AMENDMENT OF SOLICITATION/MODIFICATION OF CONTRACT

1. The specifications and drawings for Invitation No. DACW64-02-B-0002, Dredging, Main Channel in Matagorda Bay and Natural Bay Bottom Route in Matagorda County, Texas, advertised 19 October 2001, and for which bids are rescheduled to be opened on 17 January 2002, are hereby modified as follows:

**GULF INTRACOASTAL WATERWAY,
TEXAS, MAIN CHANNEL IN MATAGORDA
BAY AND NATURAL BAT BOTTOM
ROUTE IN MATAGORDA COUNTY,
TEXAS, DREDGING**

SKETCH NO. 1

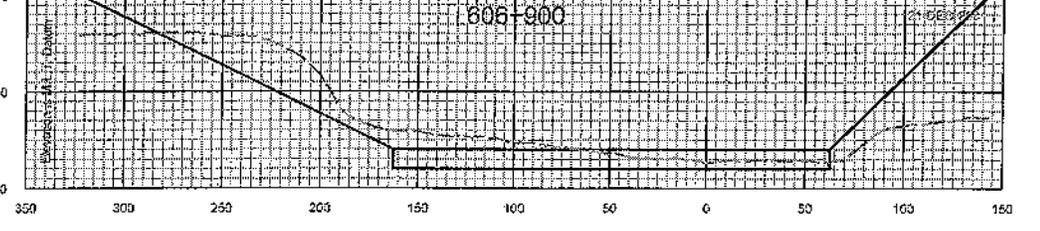
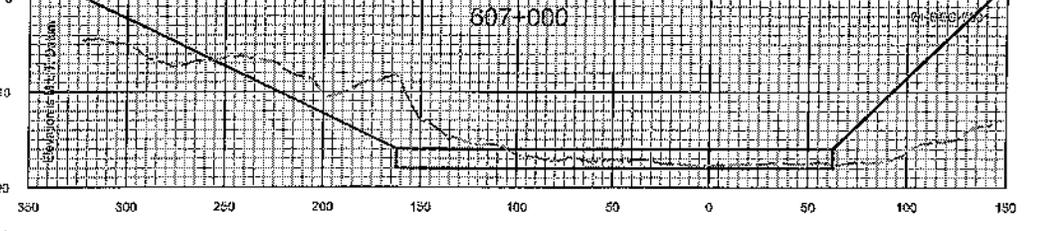
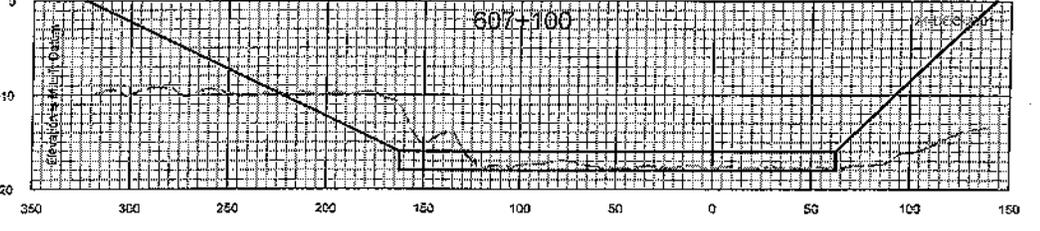
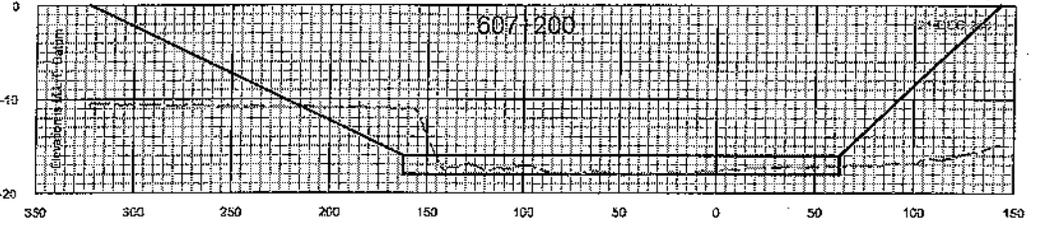
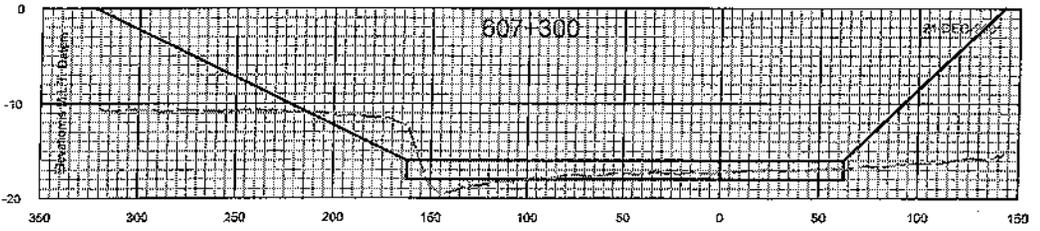
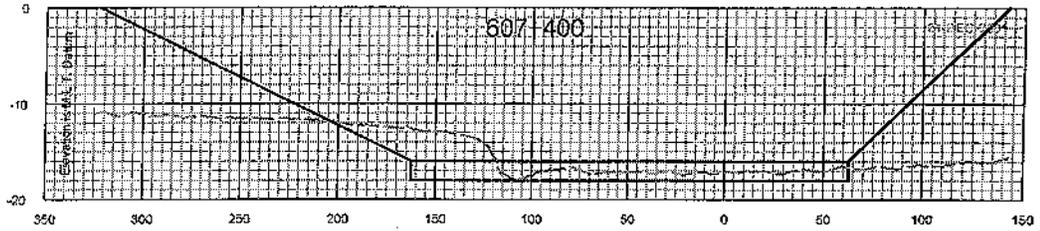
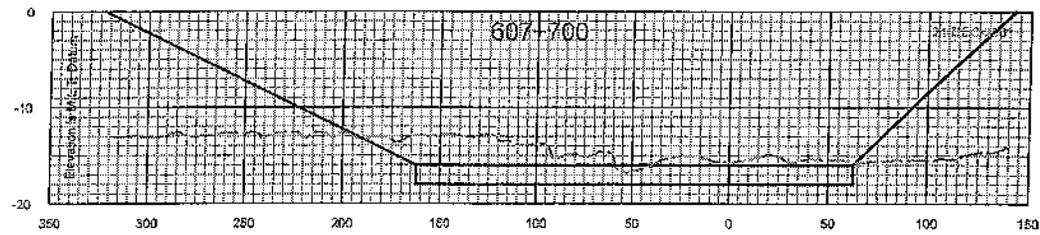
NOTE: THE CROSS SECTIONS ON THE INITIAL INVITATION REPRESENTED HISTORICAL CONDITIONS AS OF THE DATE OF THEIR PREPARATION (AVERAGE HISTORICAL CONDITIONS). THE ATTACHED CROSS SECTIONS AND ADDITIONAL SKETCHES REPRESENT CONDITIONS AS OF 21 DECEMBER 2001.

(3) SKETCHES NOS. 1, 2, AND 3. - The enclosed Sketches Nos. 1, 2, and 3 shall be attached to and become part of this Invitation.
